PARASITIC ENGINEERING POWER SUPPLY KIT

Errata

26 March 2010 Martin Eberhard

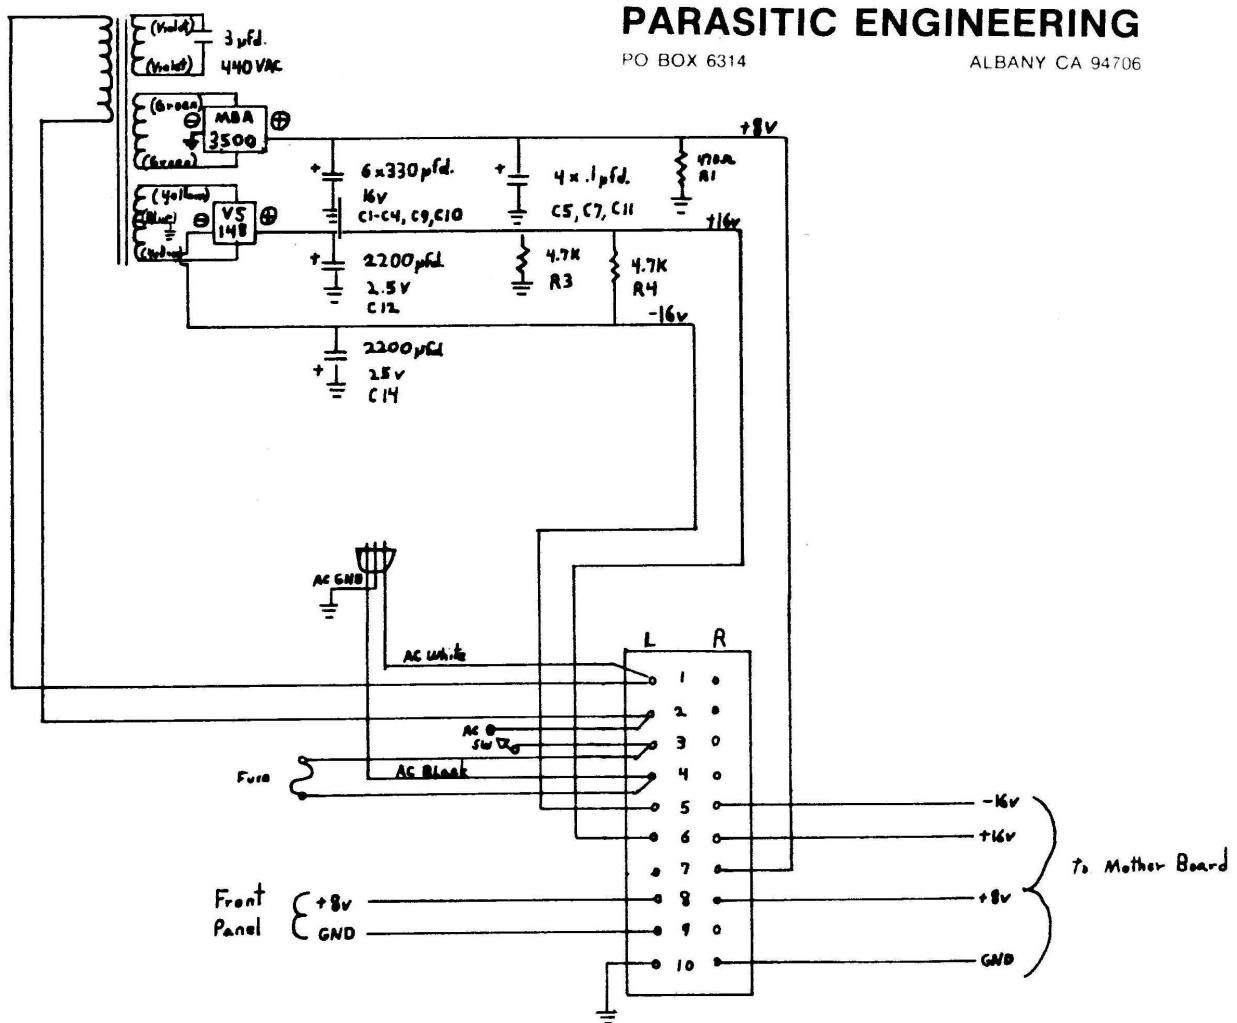
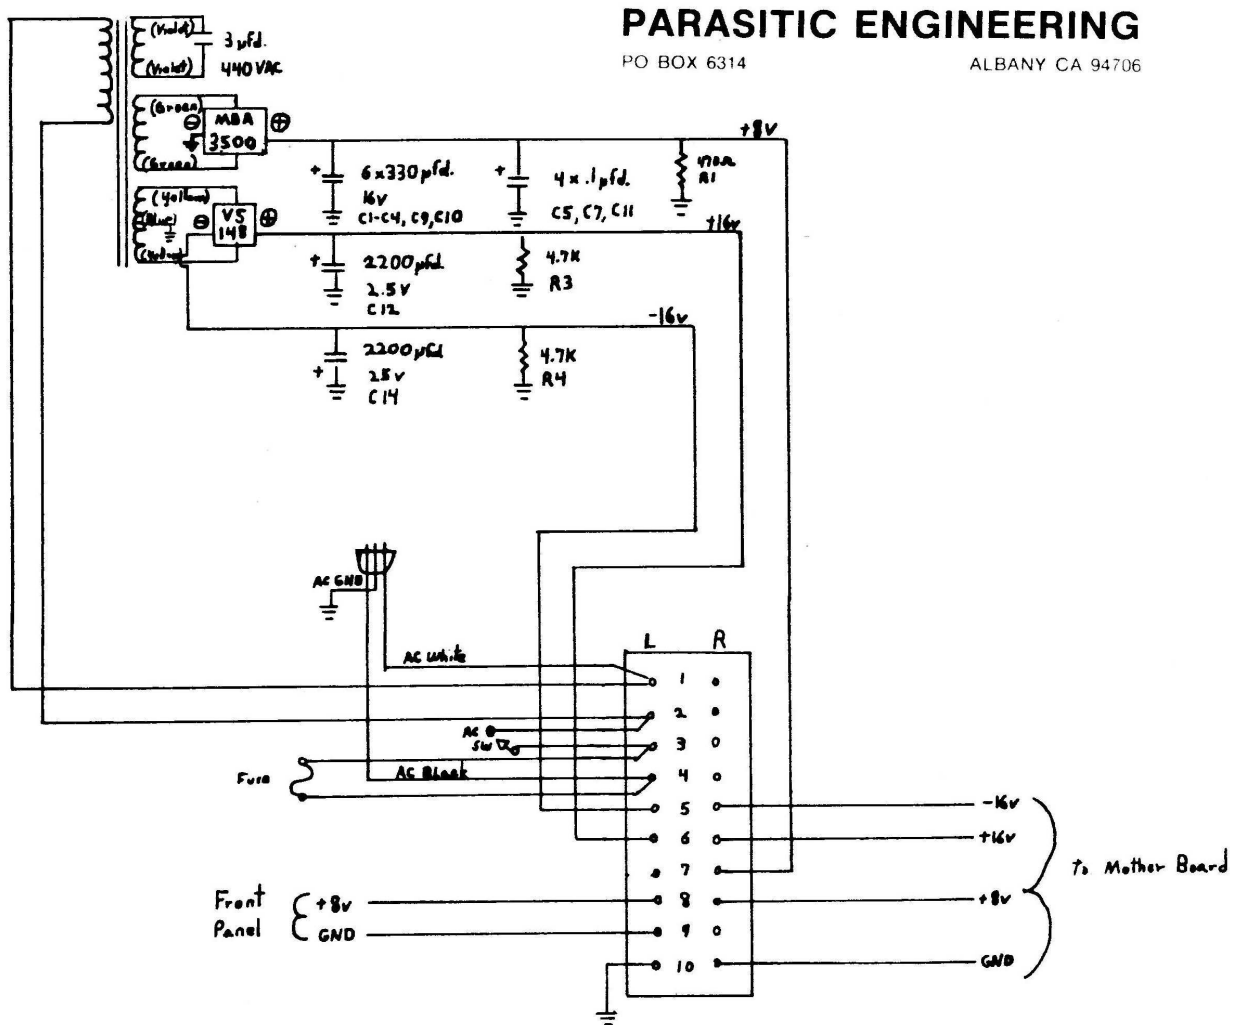
The Parasitic Engineering Power Supply Kit has a minor mistake in the bleed resistor circuit for the -16 volt circuit that can be corrected easily. This is how Parasitic Engineering intended the circuit, and how it will actually be once these errata have been implemented:

The trouble is that R4 is not actually wired as shown. If the Parasitic Engineering instructions are followed, the circuit is actually like this (Note the incorrect position of R4):

- ( ) De-solder and lift the end of R4 that is farthest from the edge of the PC Board.
- ( ) Bend R4 around so that its loose end fits into the hole nearest the board edge that was for C13. (C13 had been removed during the Parasitic Engineering modification, as had diodes D5 and D6, which were positioned between R4 and C13.) Solder R4 into its new position.

PCB ASSEMBLY DRAWINGS

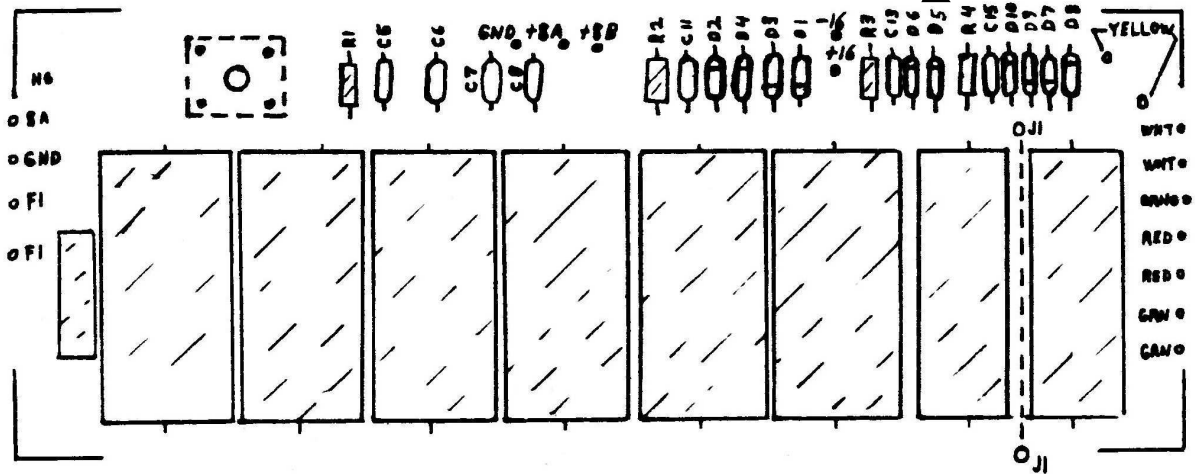
Original PCBA - Note the location of R4:

Modified PCBA - Note the new location of R4:
